Architectural Commission Report

Meeting Date: Wednesday, March 20, 2013

Subject: **TORY BURCH**
366 North Rodeo Drive
Request for approval of a revision to a previously approved façade remodel.
(PL1303478)

SHEET NO: AR-4

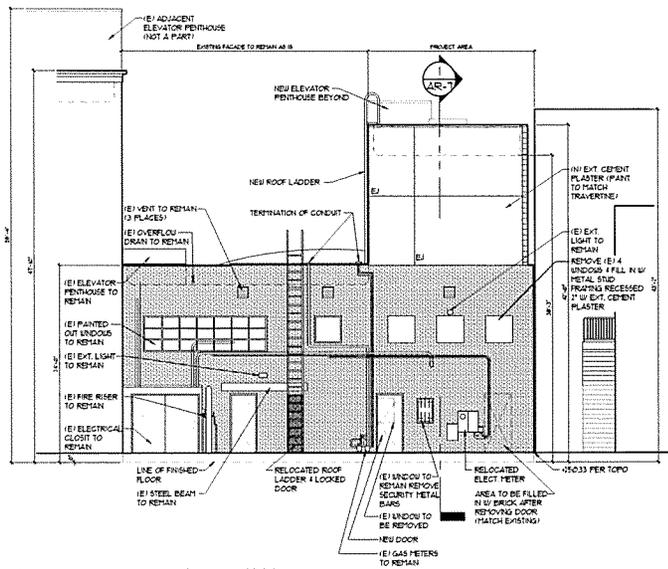
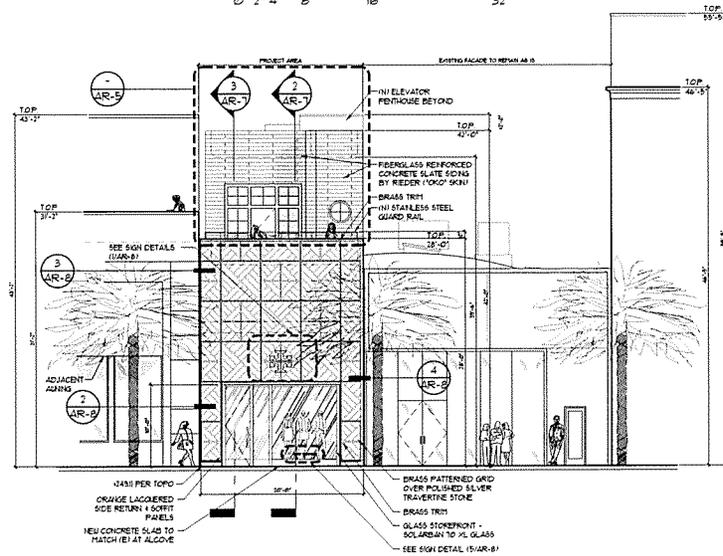
- Reconfiguration of the façade grid work;
- Reduction in height of primary façade and installation of stainless steel guardrail;
- Replacement of polished travertine stone on third floor with fiberglass reinforced concrete slate siding;
- Reconfiguration of rectangular window on third floor with a smaller circular window, and;
- Removal of four square windows on rear façade to be filled with a recessed cement plaster façade.
